Work Order ID 108687

Item Name: Crosstube Turning Detail

DRAWING NO. D412-664-245	TITLE CROSSTUBE ASS'Y (412 LOW-N AFT)	REV. D	DART AEROSPACE LTD ENGINEERING ORDER		D.E.O. NO. D412-664-245-D-1	SHEET NO. SHEET 1 OF 2	SCALE NTS
DRAWN <i>qp</i>	CHECKED <i>SC</i>	MFG. APPR. <i>E</i>	APPROVED <i>MP</i>		DE APPR. <i>#</i>		
DATE 11.05.25	DATE 11.05.31	DATE 11.05.31	DATE 11/05/31		DATE 11.05.31

DRAWING NO. D412-664-245	TITLE CROSSTUBE ASS'Y (412 LOW-N AFT)	REV. D	DART AEROSPACE LTD ENGINEERING ORDER		D.E.O. NO. D412-664-245-D-3	SHEET NO. SHEET 1 OF 3	SCALE NTS
DRAWN <i>q</i>	CHECKED <i>J</i>	MFG. APPR. <i>JD</i>	APPROVED <i>AD</i>		DE APPR. <i>AD</i>		
DATE 12.08.21	DATE 12.08.30	DATE 12.08.30	DATE 12.08.30		DATE 12.08.30

D412-664-245
ASSEMBLY DETAIL

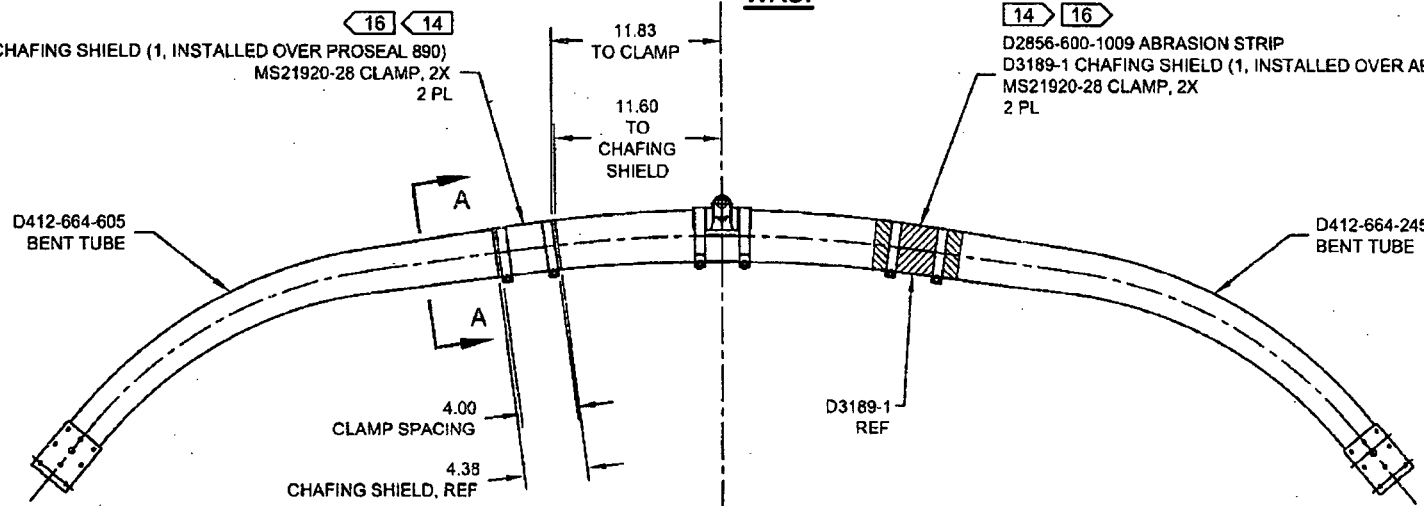
REMOVED ABRASION STRIP IN FAVOR OF A THIN LAYER OF PROSEAL 890. UPDATE INSTALLATION OF CHAFING SHIELDS AND REDUCE TORQUE TO 40-50 IN-LBS. THIS ENGINEERING ORDER SUPERCEDES DEO D412-664-245-D-1

IS:

D3189-1 CHAFING SHIELD (1, INSTALLED OVER PROSEAL 890)
MS21920-28 CLAMP, 2X
2 PL

WAS:

D2856-600-1009 ABRASION STRIP
D3189-1 CHAFING SHIELD (1, INSTALLED OVER ABRASION STRIP)
MS21920-28 CLAMP, 2X
2 PL

SECTION A-A
CHAFING SHIELD DETAIL
VIEW ROTATED, NOT TO SCALE

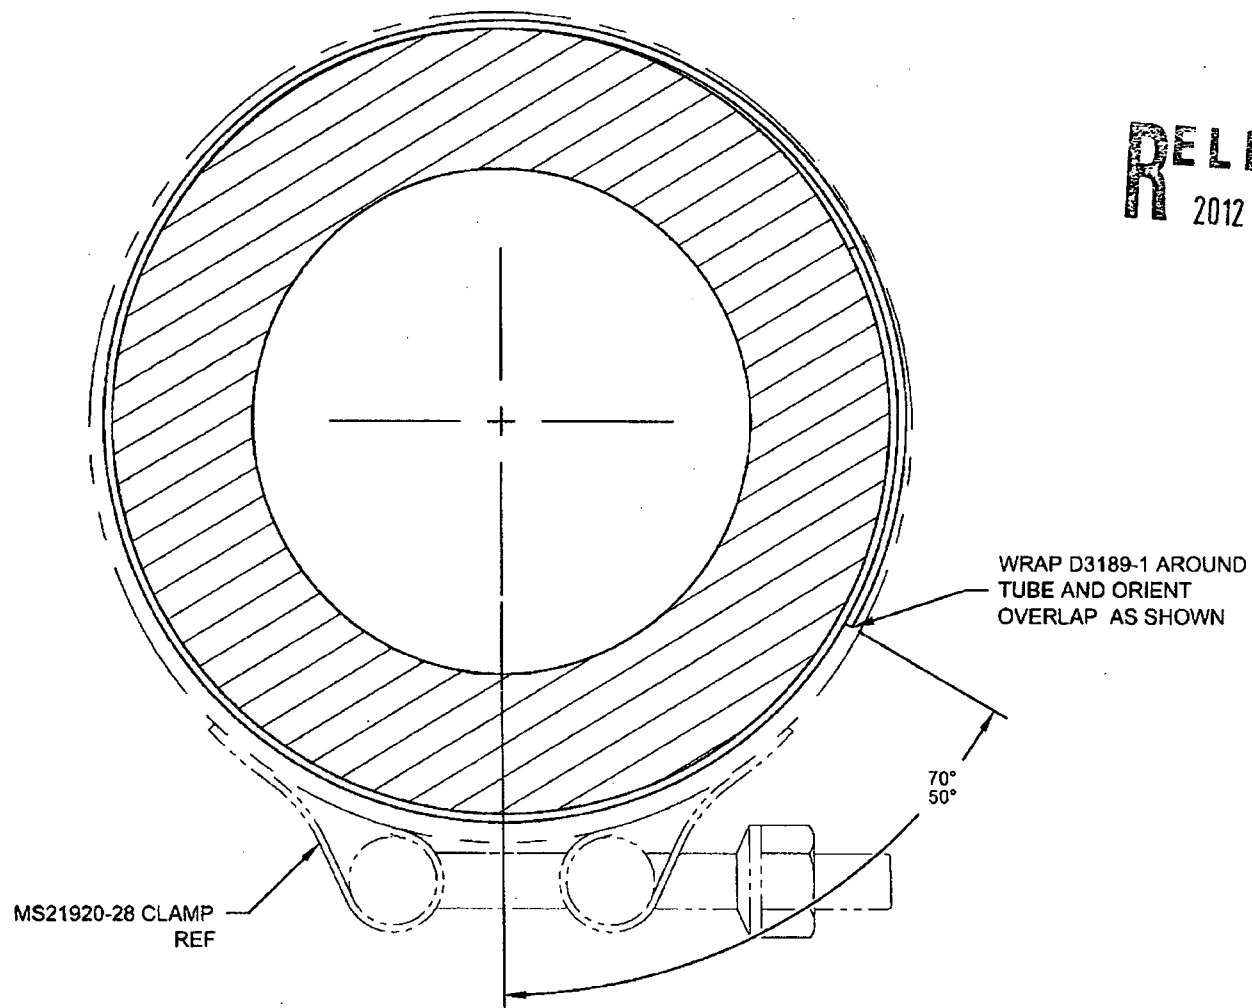
- 14) APPLY A THIN COAT OF PROSEAL 890 ON INSIDE CONCAVE SURFACE OF D3189-1 CHAFING SHIELD AND LET CURE PER MANUFACTURER'S INSTRUCTIONS. INSTALL PROSEALED D3189-1 CHAFING SHIELD ONTO CROSSTUBE BY APPLYING A THIN COAT OF PROSEAL 890 ONTO CROSSTUBE. BE SURE TO ELIMINATE ANY AIR GAPS.
- 16) TORQUE CLAMPS ON D2896-1 SUPPORT 80 TO 100 IN-LB. **TORQUE CLAMPS ON D3189-1 CHAFING SHIELD 40 TO 50 IN-LB.** ENSURE AT LEAST 1.5 THREADS SHOWING IN SAFETY AND THAT NUT HAS NOT BOTTOMED-OUT AFTER TORQUING.
